INTERSTATE ROUTE H-2 HOV LANES, PHASE I
WAIPIO TO WAIAWA INTERCHANGE
Project No. IR-H2-1(26)

STATE OF HAWAII DEPARTMENT OF TRANSPORTATION HIGHWAYS DIVISION	
RETAINING WALL PLAN AND ELEVATION	
I.B. STA. 375+00 TO STA. 376+97	
I.B. STA. 403+75 TO STA. 406+00	
INTERSTATE ROUTE H-2, HOV LANES, PHASE I	
WAIPIO INTERCHANGE TO WAIPILO INTERCHANGE	
Project No. IR-H2-11(26)	
Scale: As Noted	Date: Jan. 1991
SHEET No. S2 OF 20 SHEETS

"AS-BUILT"

REINFORCING AT 36"Ø CMP
OUTBOUND @ STA. 376+67±
PART ELEVATIONS AT CMP OPENINGS
Scale: 1/2"=1'-0"

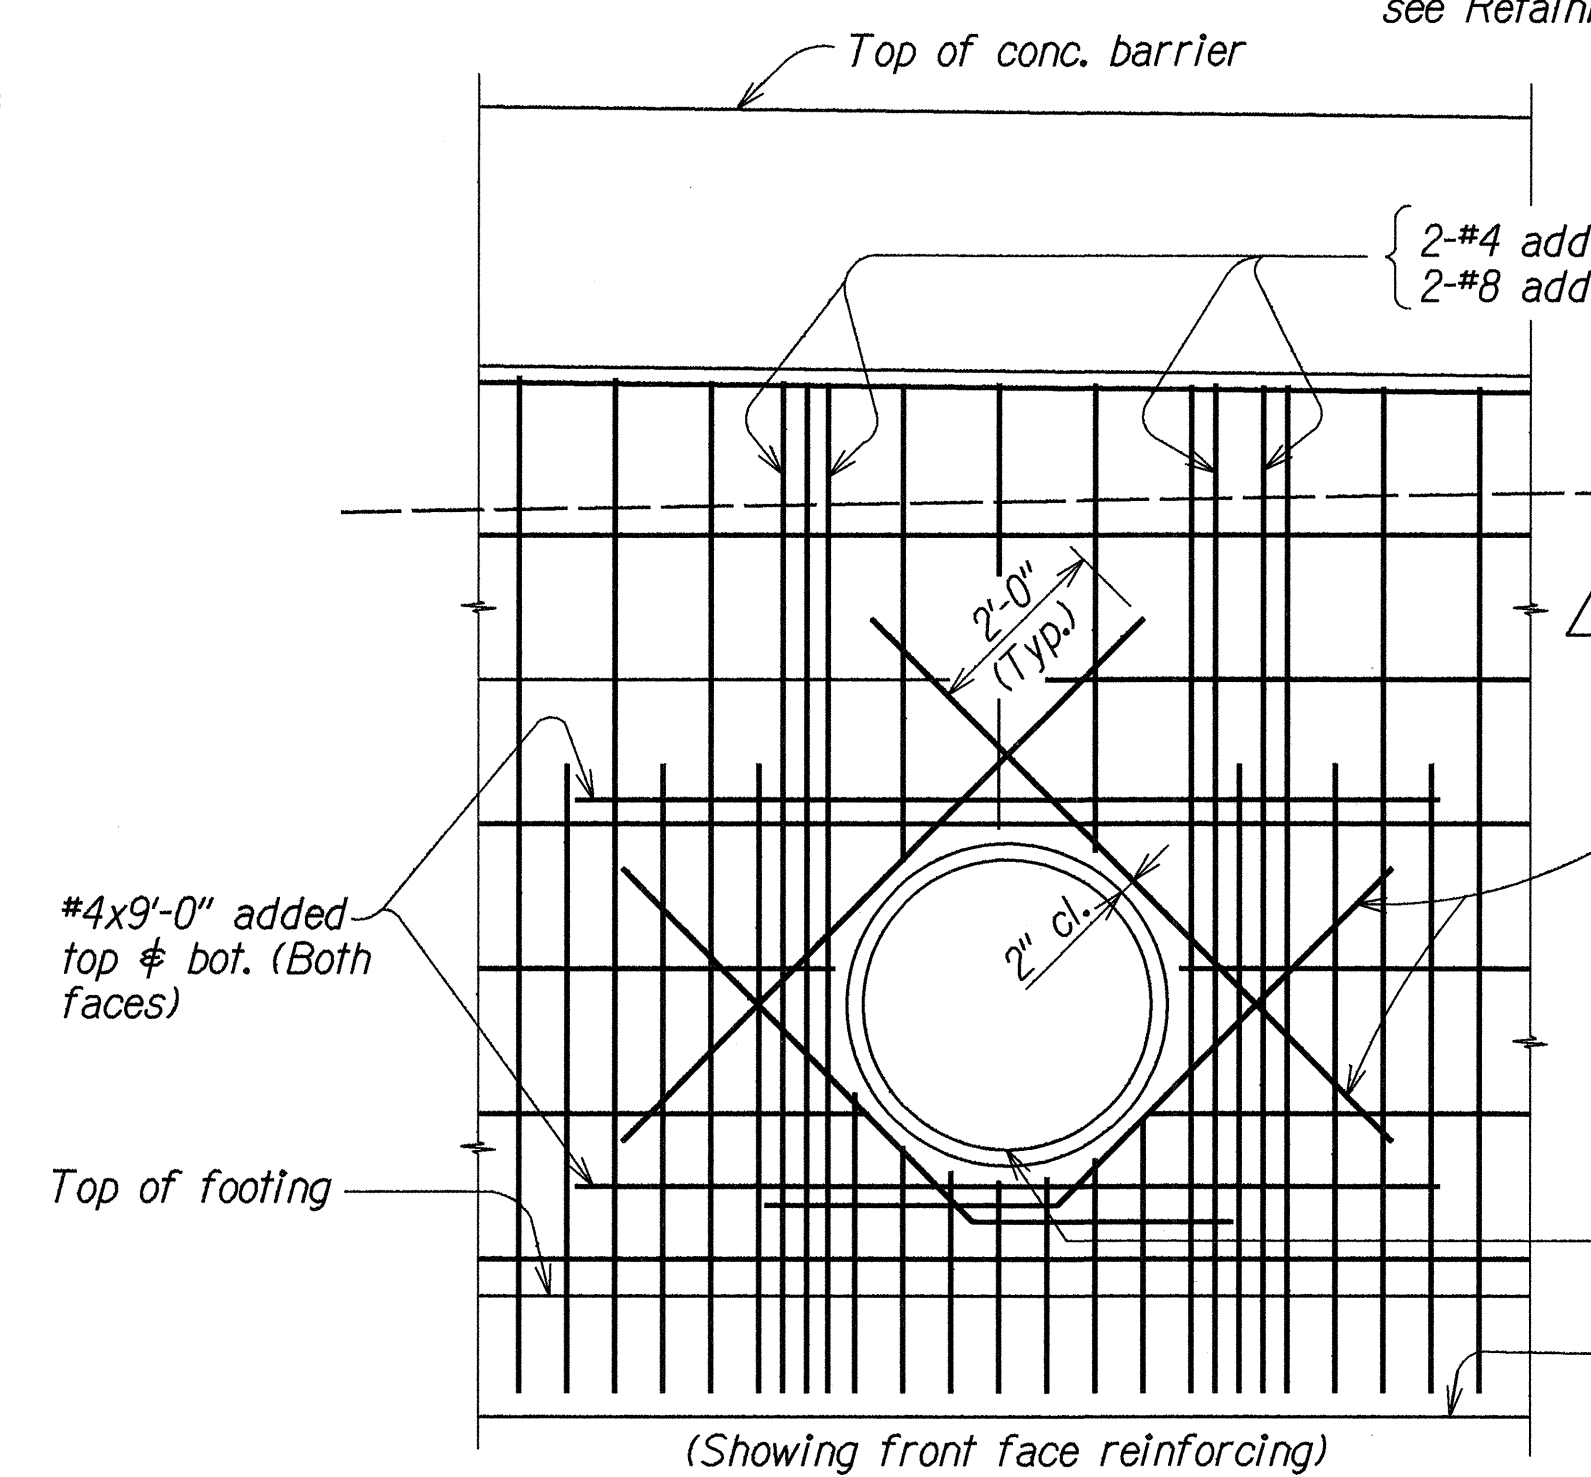
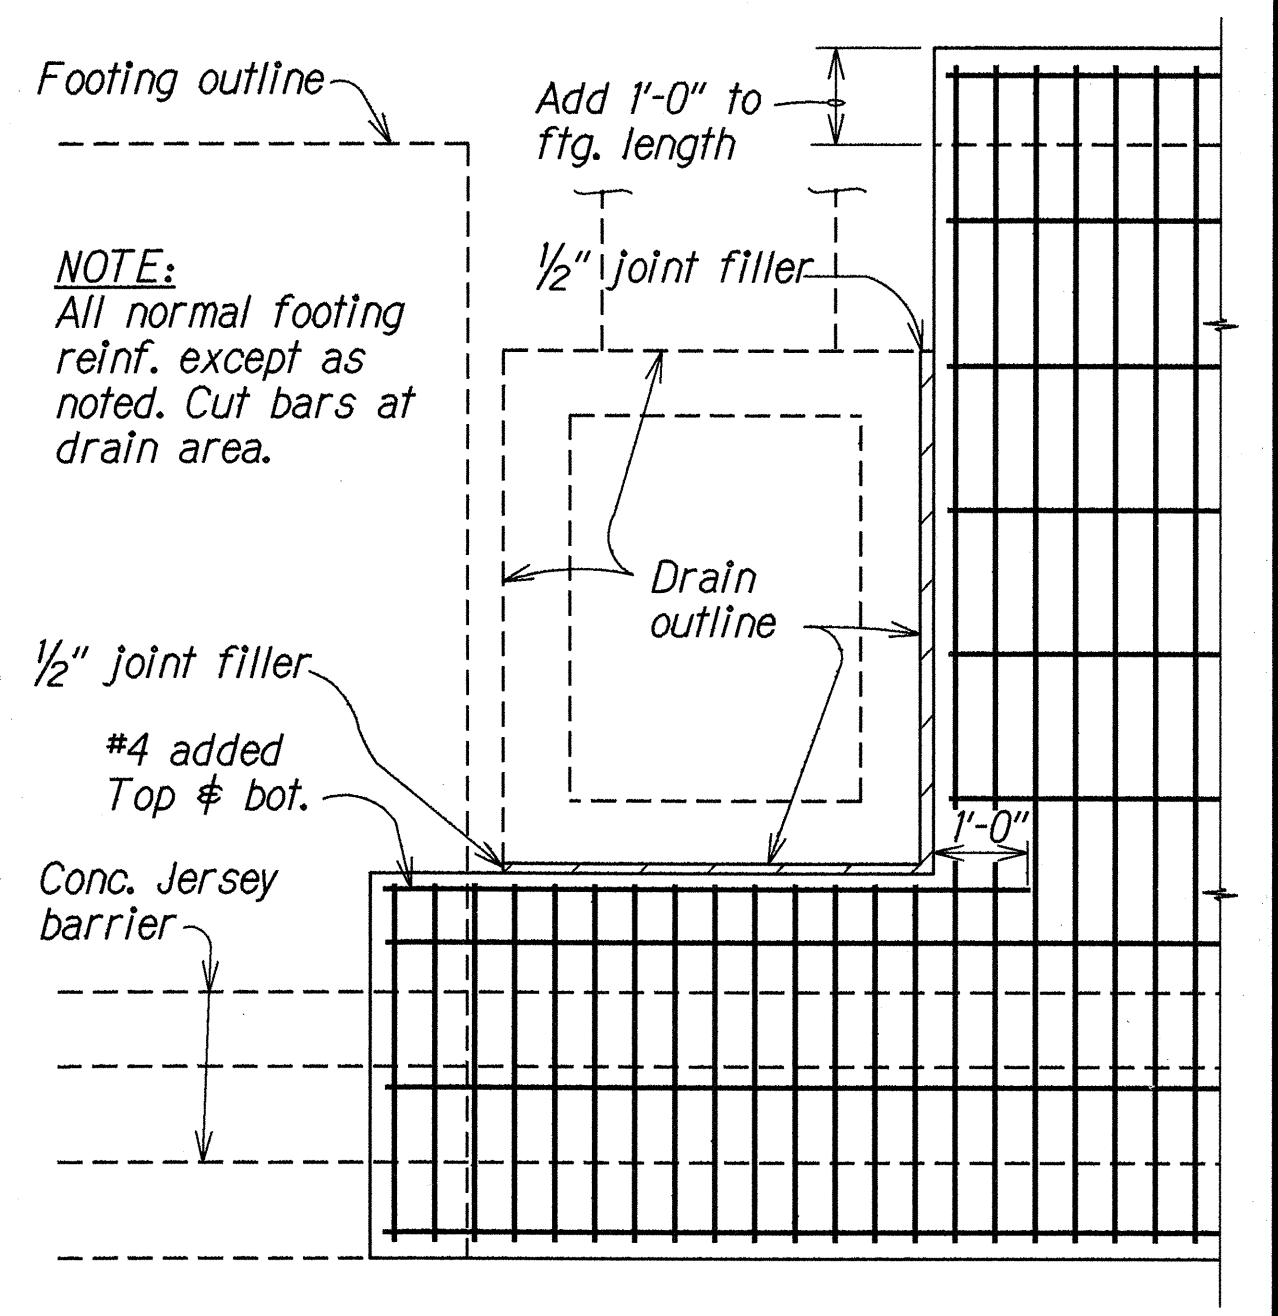
DATE	REVISION
11/14/91	Corrected INBOUND to OUTBOUND. Changed "h" to top ret. wall.
6/24/91	Corrected invert elevation & location of CMP at I.B. @ Sta. 419+25.0 & removed arrows from horizontal reinf. at 36"Ø CMP. Removed h=6' Vertical Reinf. Steel Arrangement At Cut Side.
